**City of Glendale
Community Development Department
Design Review Staff Report – Multi-Family**

Meeting/Decision Date: October 11, 2021	Address: 3419 Montrose Avenue
Review Authority: ☐ DRB ☒ ADR ☐ HPC ☐ CC	APN: 5607-004-032
Case Number: PDR2106786	Applicant: Helbert Moradian
Prepared By: Danny Manasserian, Planning Associate	Owner: Arbita Nersesian

The applicant is proposing to construct additions at the front and rear of the existing house, build a new two-story residential unit and garages behind the house, and demolish the existing garage. The property is located in the R-3050 (Moderate Density Residential) zone.

PROPOSED SOUTH ELEVATION
1/4"=1'-0"

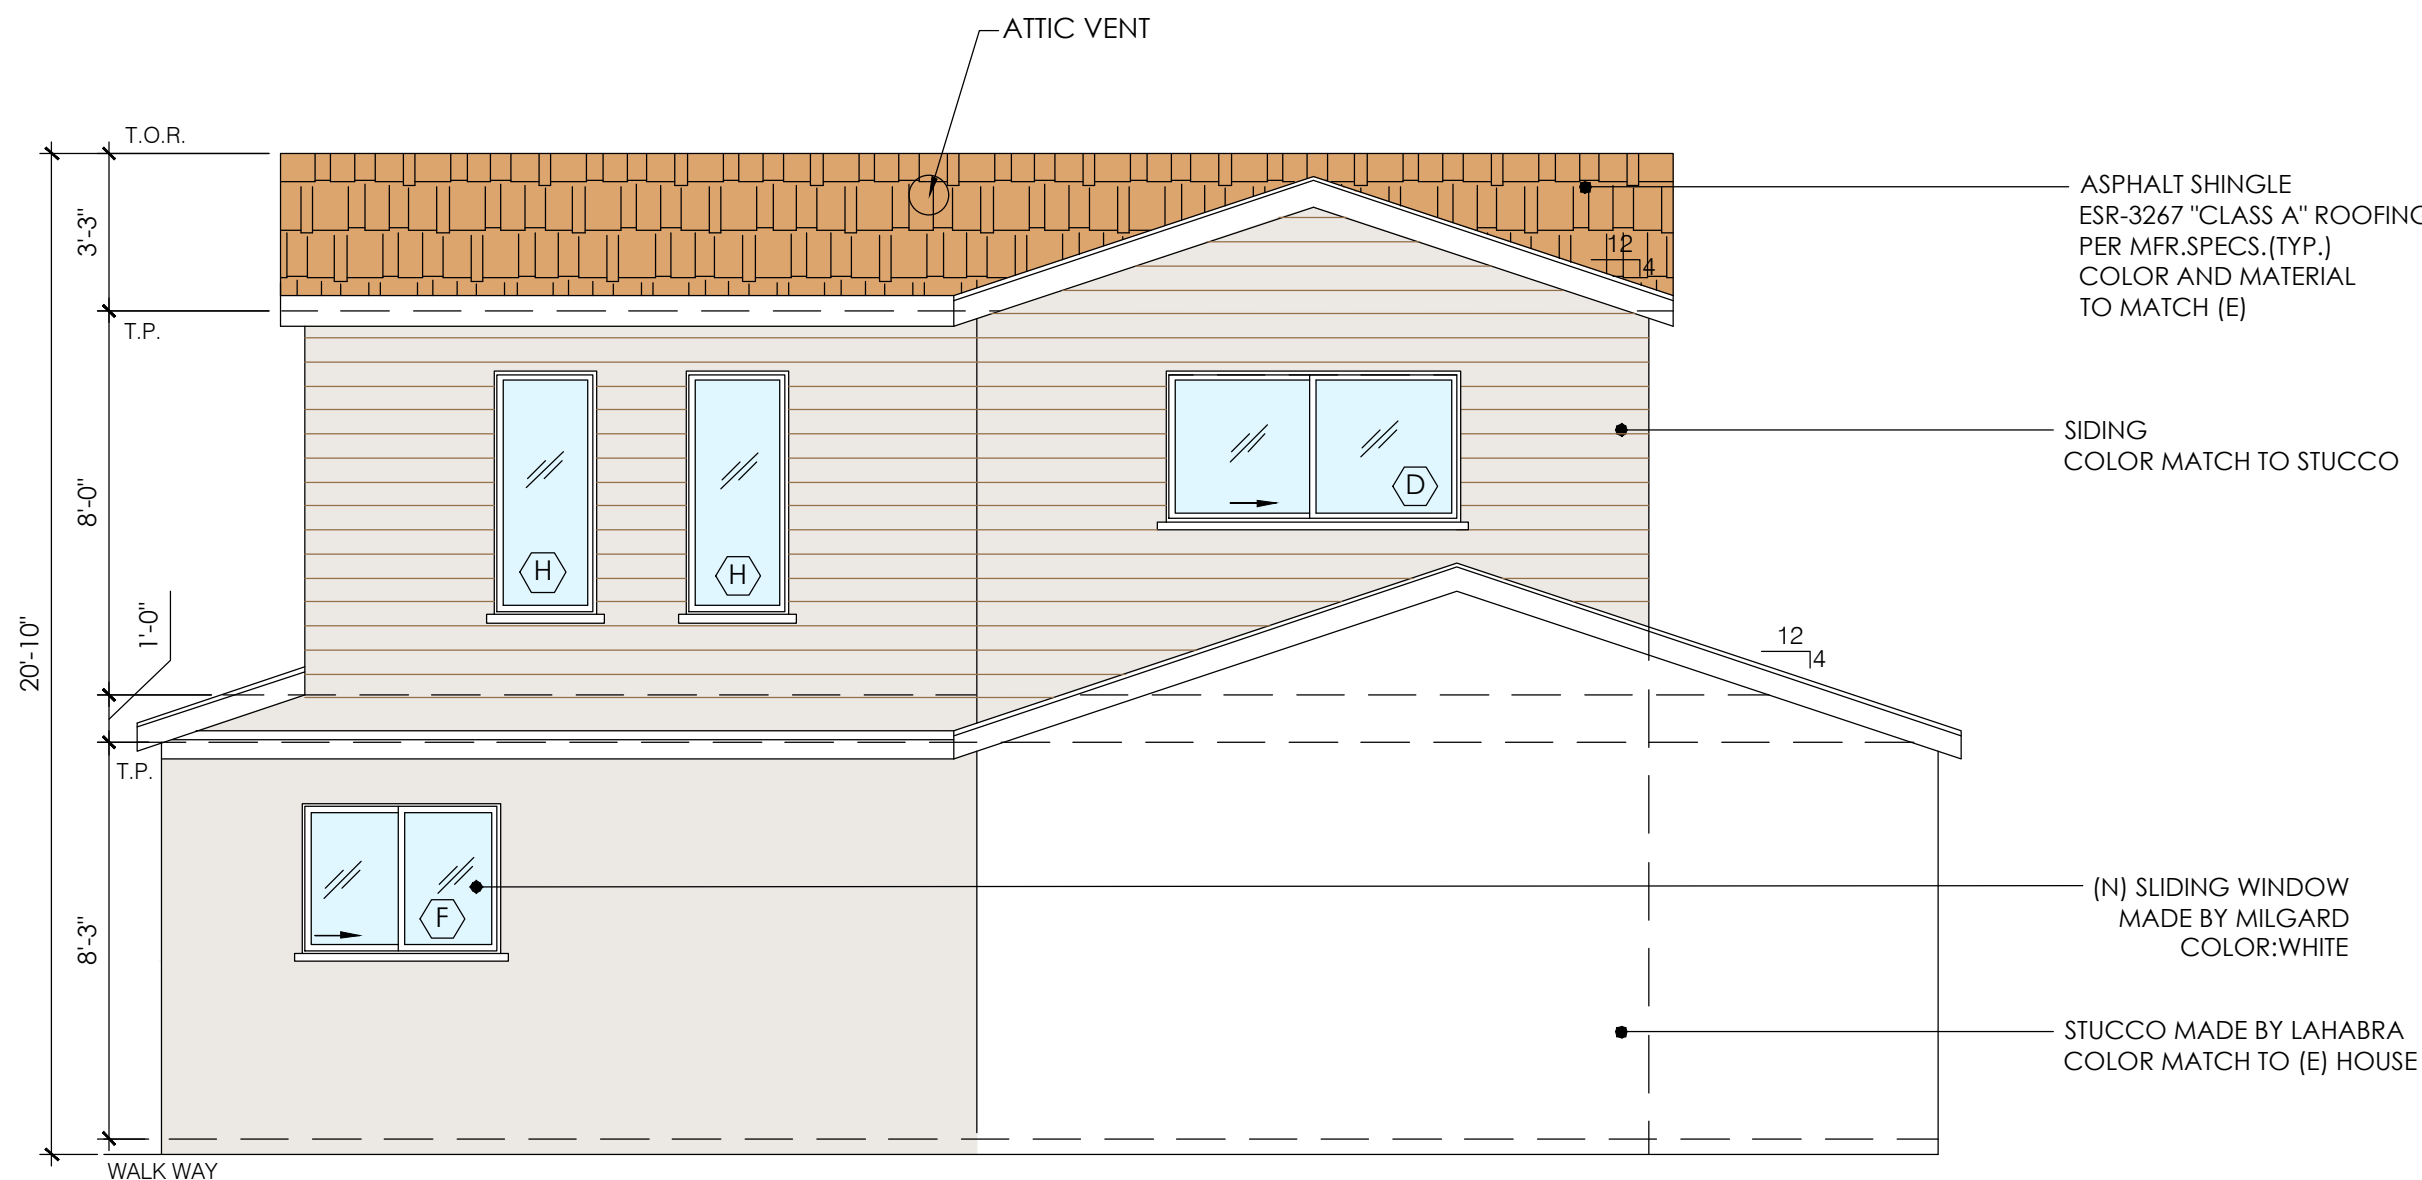
The design will be enhanced if the siding color is somewhat darker, rather than the same as, the color of the walls. A condition to this effect is added.

- The traditional design of the new unit is appropriate to the neighborhood and the existing house.
- The placement of the proposed cement fiber siding on the new unit is appropriate, however, as proposed, the color is the same as the stucco. A condition has been added to choose a somewhat darker color to complement the white stucco.
- All windows will be vinyl, recessed with a wood sill and frame to match the proposed windows on the front house. As proposed, the windows are appropriate to the design and the neighborhood in terms of their operation and overall appearance.
- The roof material includes brown composition shingle, matching the front house.

1. Propose somewhat darker color for cement fiber siding at new unit for staff review.
